# Sierra Forest Legacy

October 21, 2013

**Re: Comments on the draft environmental assessment for the Bald Mountain Project**

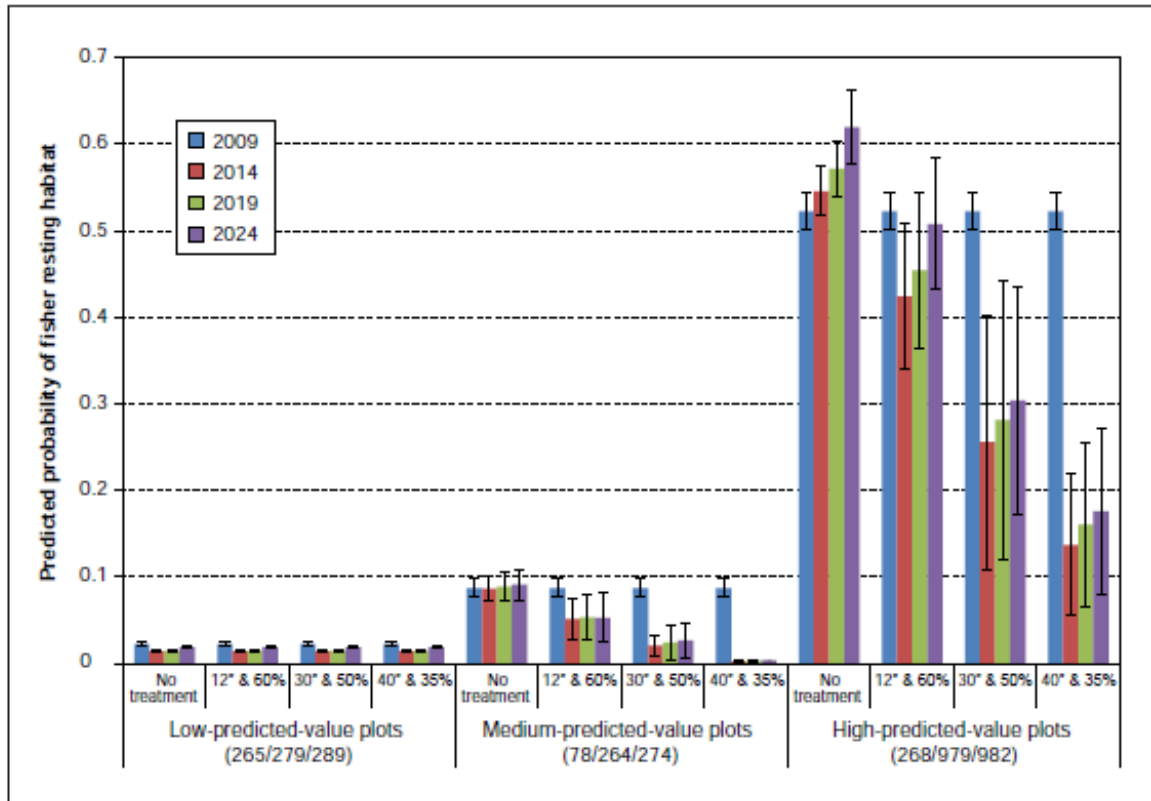
The BE (p. 89) states that habitat is expected to recover to pre-treatment conditions within 15 years. There is no analysis or evidence used to support this claim. To the contrary, recent assessments of habitat conditions for fisher following treatments suggest that habitat conditions may not recover for more than 15 years following treatment. Zielinski et al. (2010) examined the effects of treatment on rest sites. This study found that depending on treatment, it could take more than 15 years for a rest site to recover to its pre-treatment condition. Figure 2 illustrates these results and indicates that when treatments remove trees up to 30" dbh and reduce canopy cover to 50% (treatments with similarities to those proposed in Bald Mountain), the probability of the habitat supporting resting remains reduced for over 15 years post-treatment.

Results from a second study also conflict with the claims of “recovery” made in the BE. Thompson et al. (2011) examined modeled changes in home range conditions following simulated treatments and a period of growth. This study found that for an attribute like canopy cover that pre-treatment conditions were not achieved for at least 30 years. Both of these assessments suggest that the claims in the BE that habitat will recover within 15 years cannot be supported. These studies indicate that assumptions in the BE would lead to an under estimate of treatment effects. The BE should be revised to reflect these studies and the conclusions about effects adjusted accordingly.

This idea of recovery is embedded in the effects analysis presented in the EA for both CSO and fisher and used to characterize the effects of the project as minimal. Please revise the effects analysis to reflect a longer recovery period and reassess the conclusion about significance of the short term habitat changes.
